PLAN-021955

Proposal: Single storey rear extension.

Site: Highlands, Fontwell Avenue, Eastergate, PO20 3RU.

EG/14/18/HH

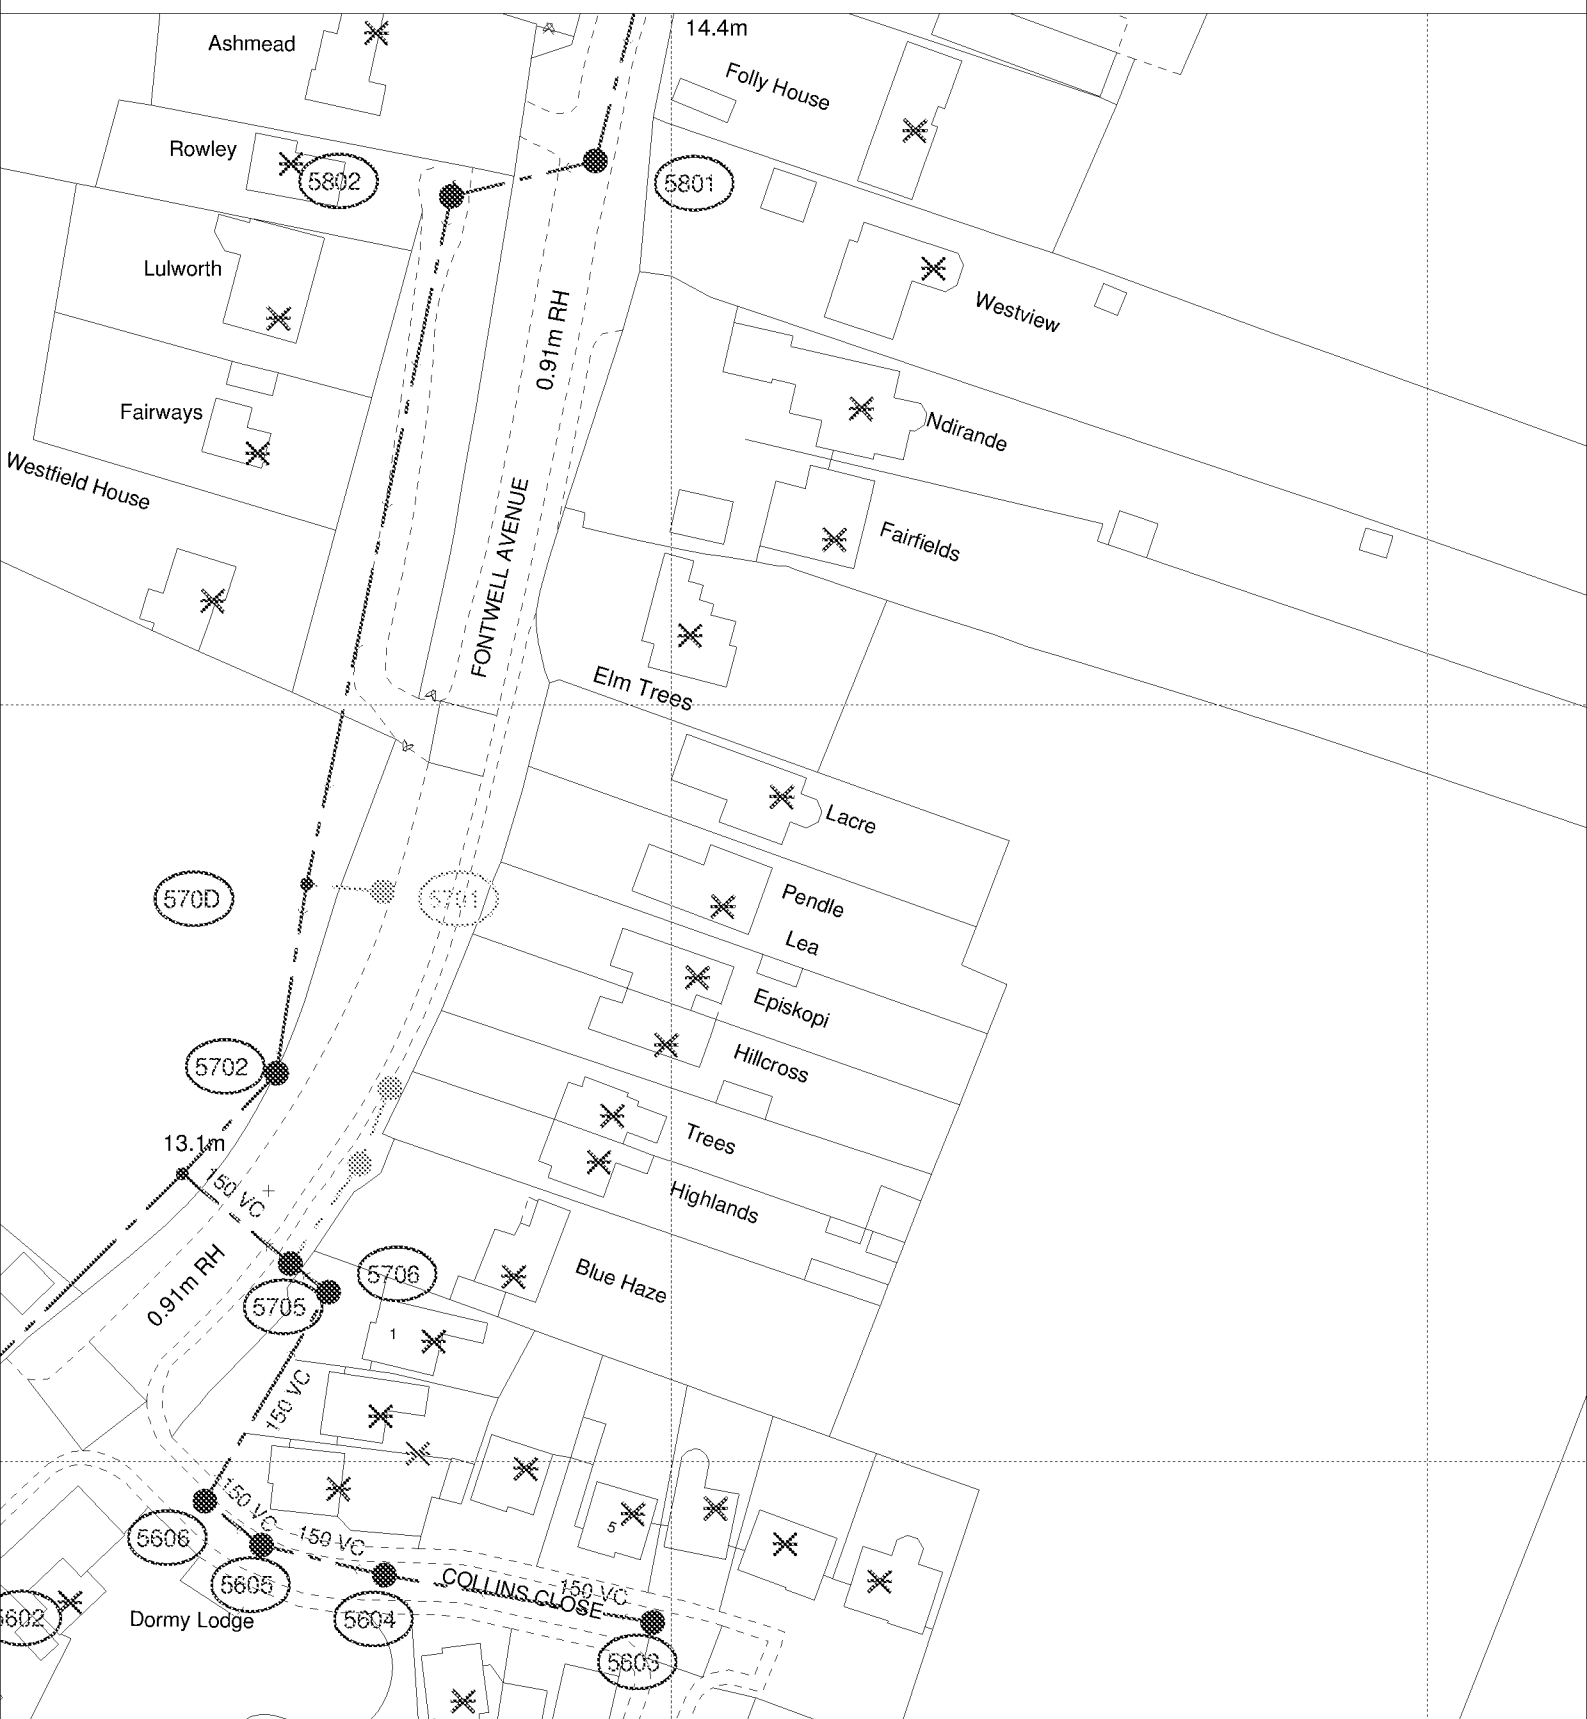
Due to surface water inundation issues in the Lidsey Catchment "The applicant is advised to adopt, where appropriate, the measures in the table "Practical measures to reduce the potential impacts of development".

Developer should look to protect the public sewerage system from inundation and infiltration, which contribute to flooding in unfavourable conditions.
